# UNITED STATES PATENT AND TRADEMARK OFFICE

10/590,472

<b>Office Action Summary</b>	<b>Application No.</b> 10/590,472	<b>Applicant(s)</b> BELLEY ET AL.	
	<b>Examiner</b> TIMA M. MCGUTHRY-BANKS	<b>Art Unit</b> 1793

## **DETAILED ACTION**

Doutre et al (US 5,827,982), cited in the search report, teaches a portable liquid metal filtration device as shown below in FIG. 1:

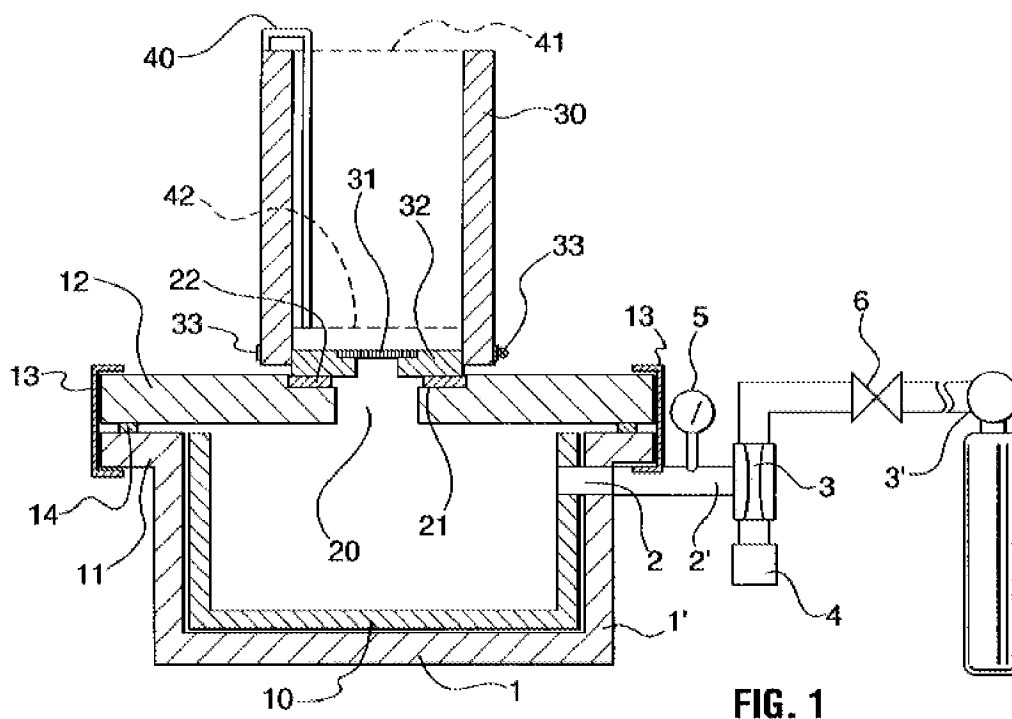
Regarding Claim 1, Doutre et al does not disclose or suggest closing the molten metal outlet shown by the area around the filter 31 with a sealable cover and then removing the sealable cover from the molten metal outlet as claimed. Regarding Claim 14, Doutre et al does not disclose or suggest a discharge trough, a vertically movable closure unit or a means for raising and lowering the closure unit as claimed.

Mochizuki et al (US 4,817,918) teaches an apparatus for filtering scraps of light metal as shown in Fig. 1:

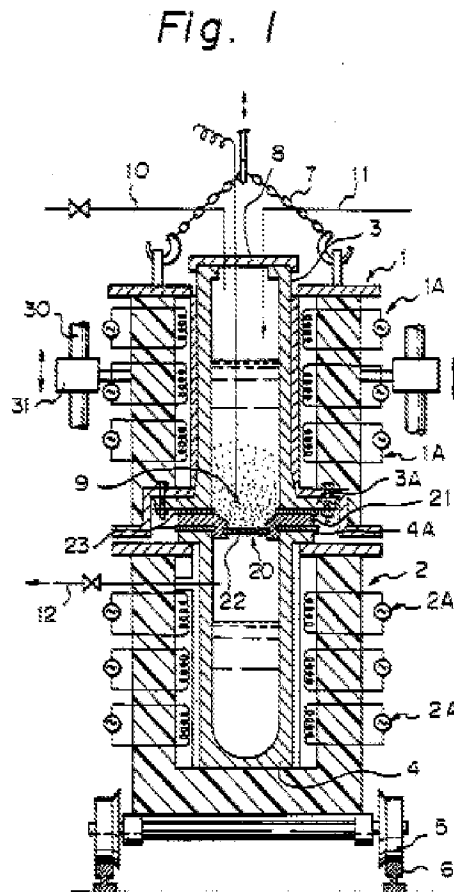
Upon achieving the required filtering temperature, the interior of the upper crucible 3 is pressurized (column 5, line 65-67), or the crucible 4 is depressurized (column 6, line 1).

Regarding Claim 1, Mochizuki et al does not disclose or suggest closing the molten metal outlet shown by the area around the filter 20 with a sealable cover and then removing the sealable cover from the molten metal outlet as claimed. Regarding Claim 14, Mochizuki et al does not disclose or suggest a discharge trough, a vertically movable closure unit or a means for raising and lowering the closure unit as claimed.

Fig. 1

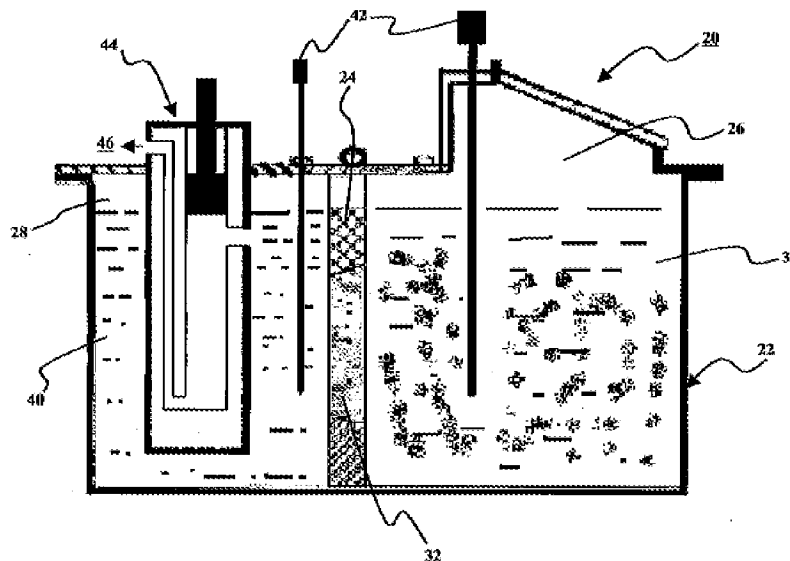
WO '748 teaches a closeable outlet at 44, which is an extractor that uses a piston (page 6 lines 24-27). Regarding Claim 1, WO '748 does not disclose a filter mounted substantially horizontally, applying a vacuum, withdrawing a stream of air through a fan or air venture and releasing the vacuum as claimed. Regarding Claim 14, WO '748 does not disclose a filter mounted substantially horizontally, an exit well beneath the filter, a trough, an air conduit and valve as claimed.
